Subject: **Bid No. 8828-M7 – Roof Replacement – 76 East Worcester St / DPW**

ADDENDUM NO. 1

ROOF REPLACEMENT & REPAIRS
76 E. WORCESTER ST.
WORCESTER DPW

A1

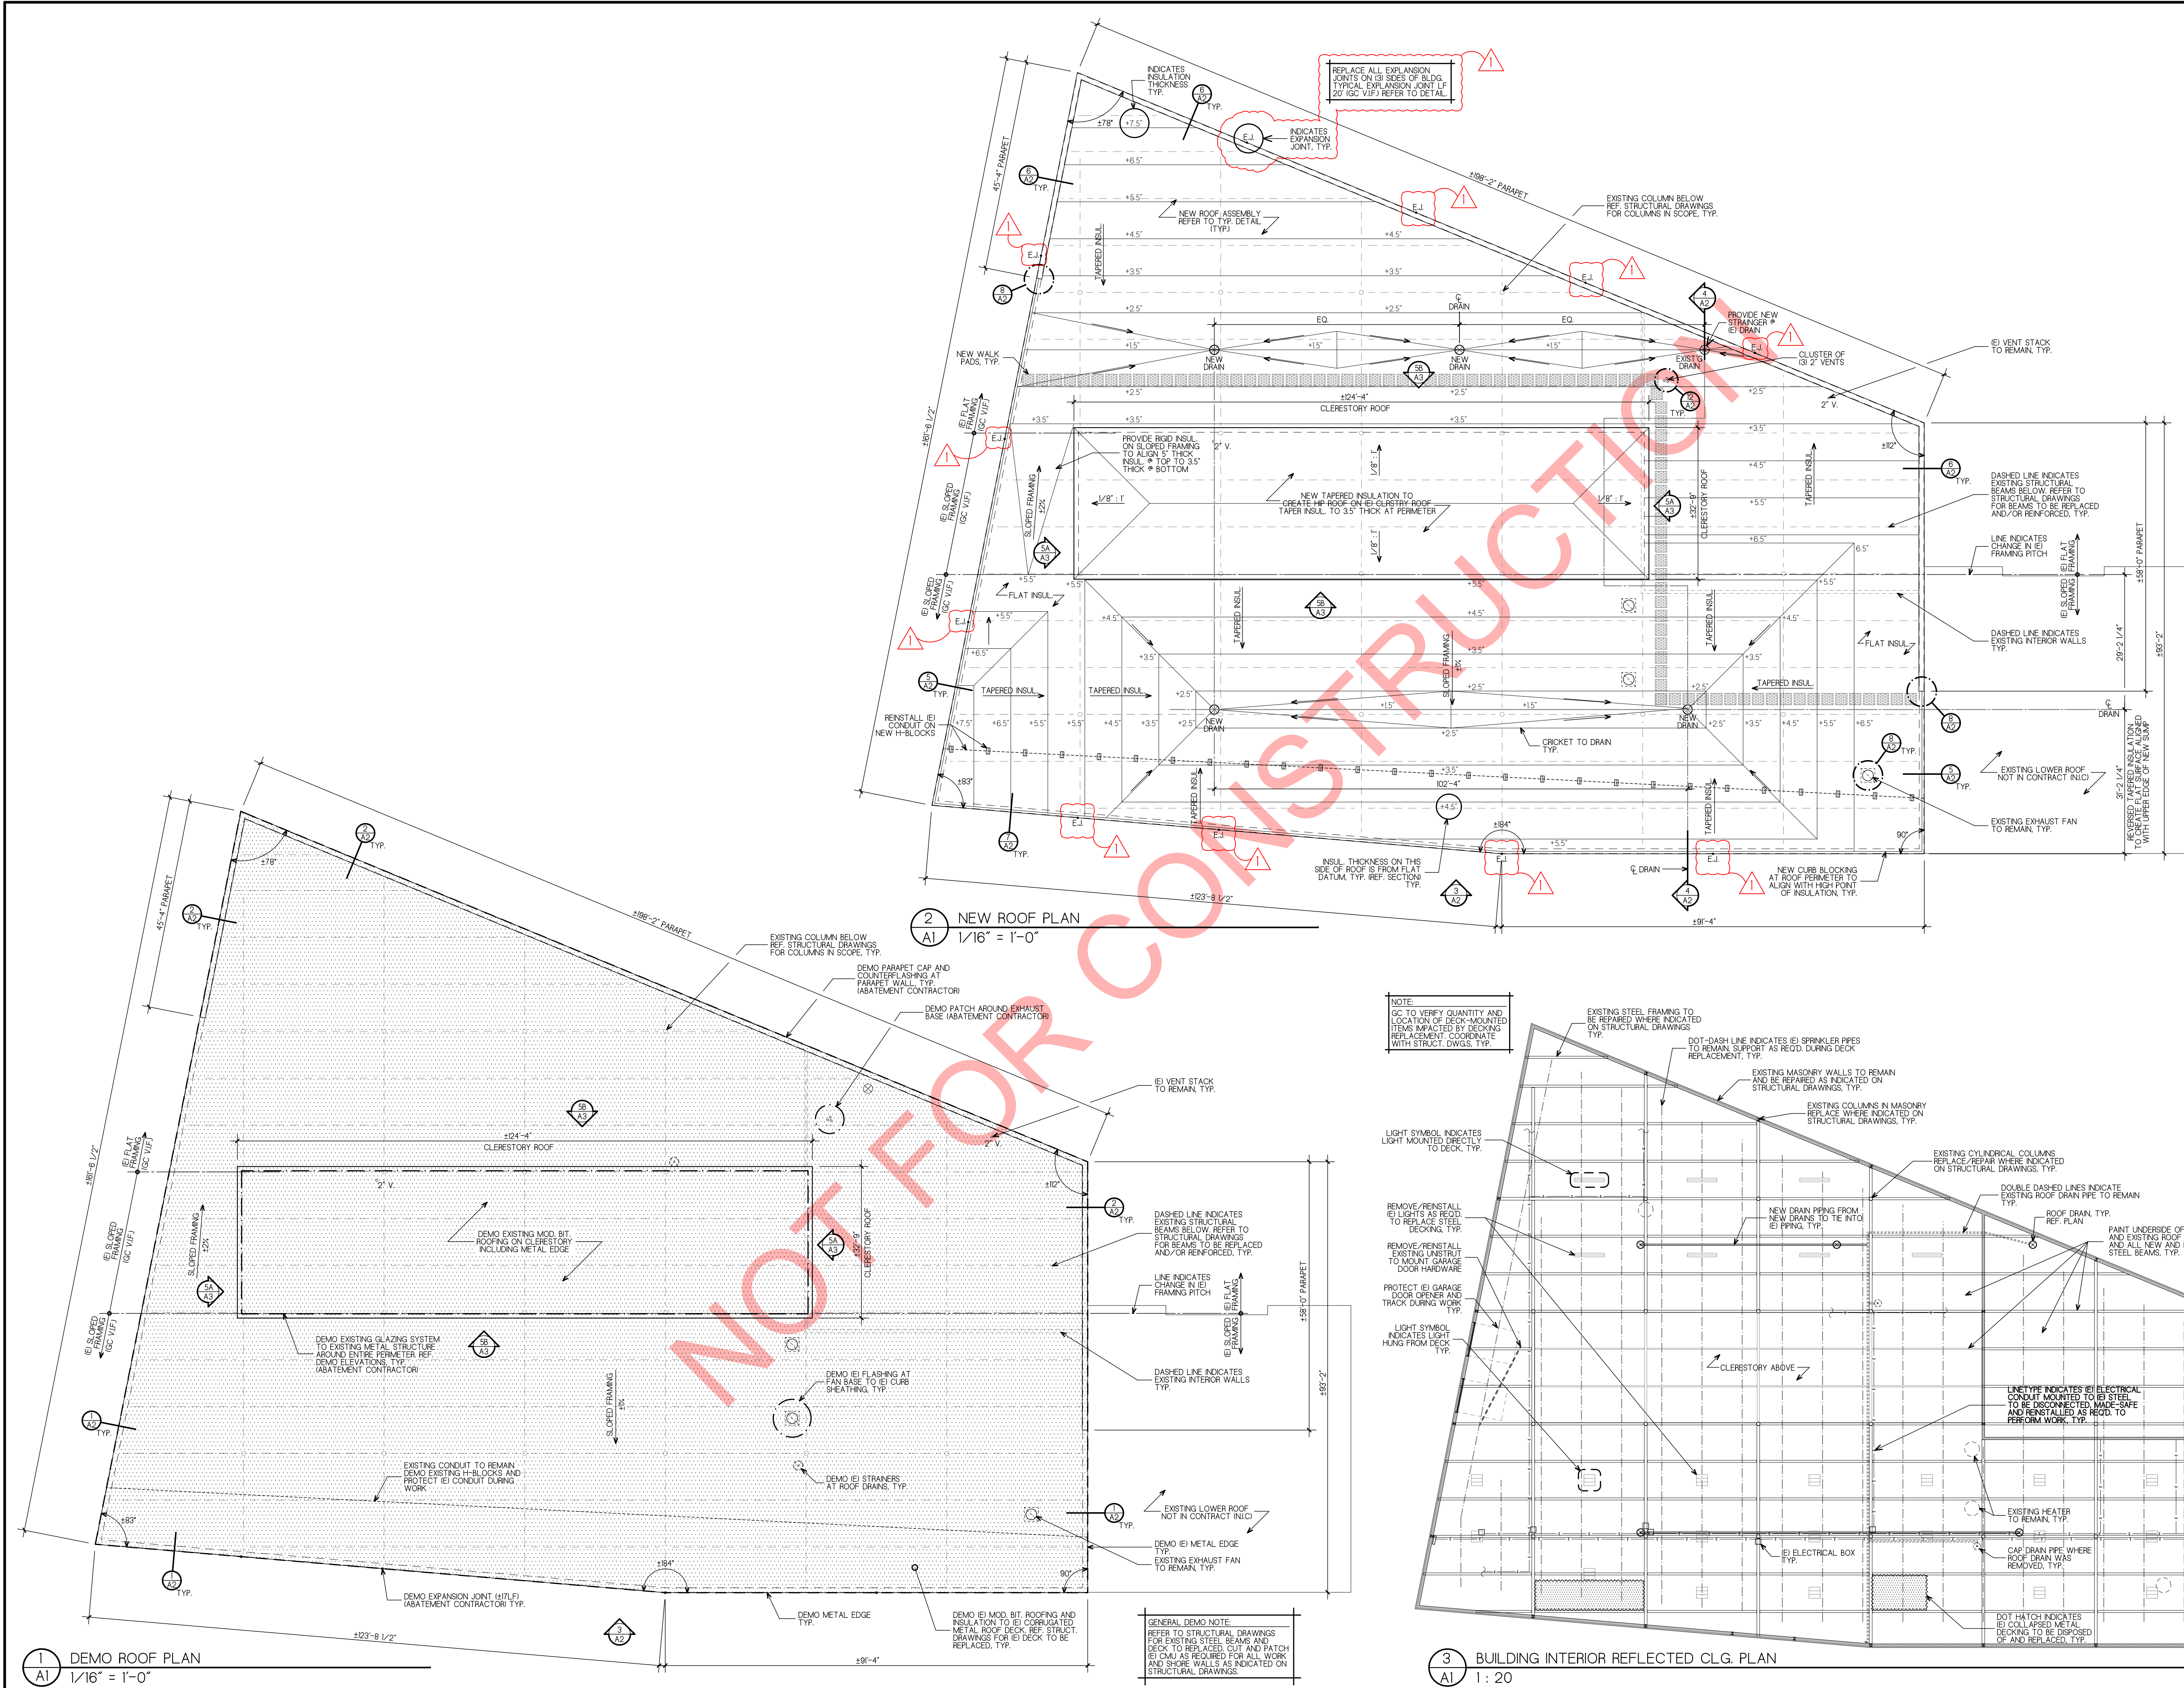
14. How many locations of expansion caulking are on that side of the building?

A: 4 locations on that side of building. Refer to updated drawing sheet A1 on (1) 24 x 36.
